SEWAGE DISPOSAL SYSTEM

MARYLAND STATE DEPARTMENT OF HEALTH

SUBDIVISION Green Hill Manor ROAD Montell Court LOT 2, Blk. A

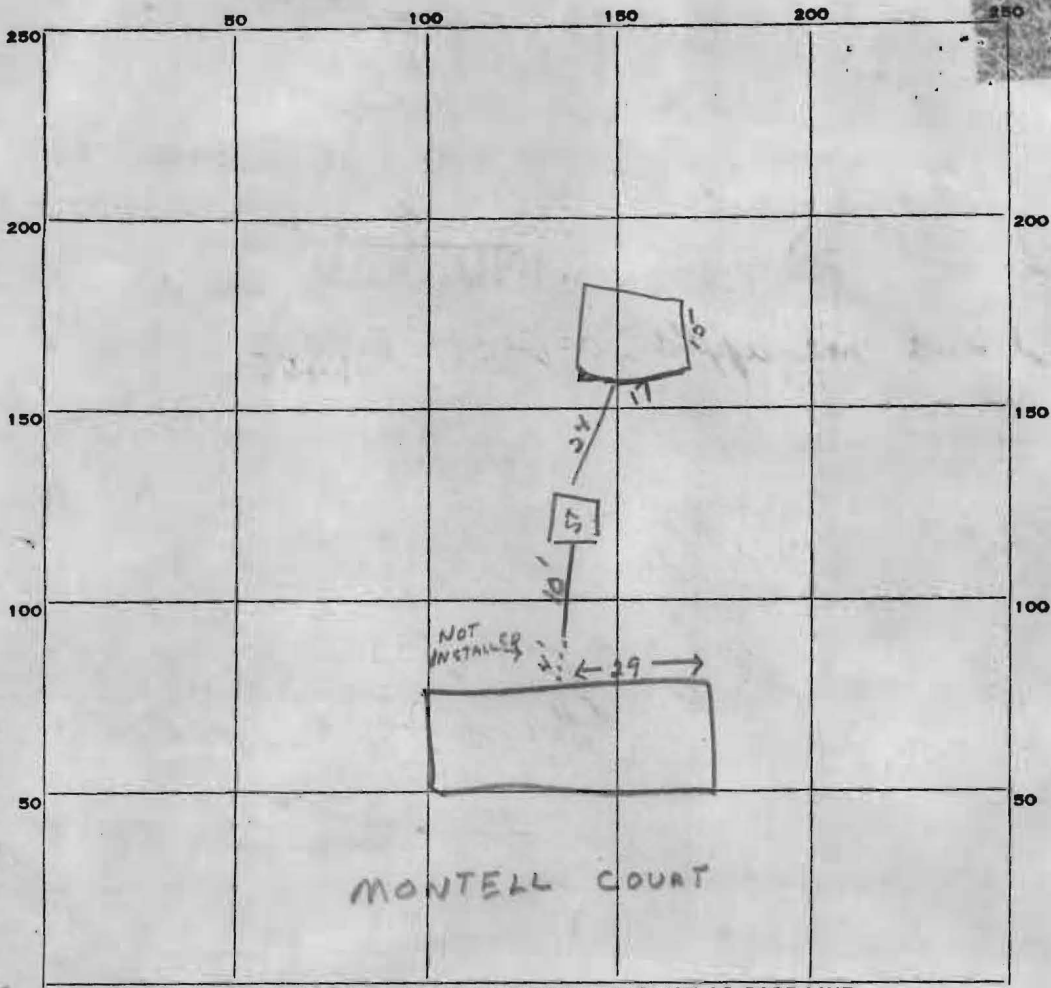
OTHER Dry well - 300 sq. ft. sidewall area below inlet ⁵ ft. deep. Max. depth
permitted ¹³ ft. unless visual inspection of hole allows you to go further down.

Place the dry well 100 ft. to 130 ft. from the back lot line and 20 ft. to 50 ft.
from the left side of the lot as seen when facing the lot from Montell Court.

12-15-72. depth & inlet changes per visual hole S.F.

REMARKS 1/26/73 - To call for final after crack in dry well lid is closed and dry well is completely backfilled with stone
2/26/73 D. Well completely covered. Needs RT cap for dry well cleanout. Hold & discuss with Supervisor or R.T. OK
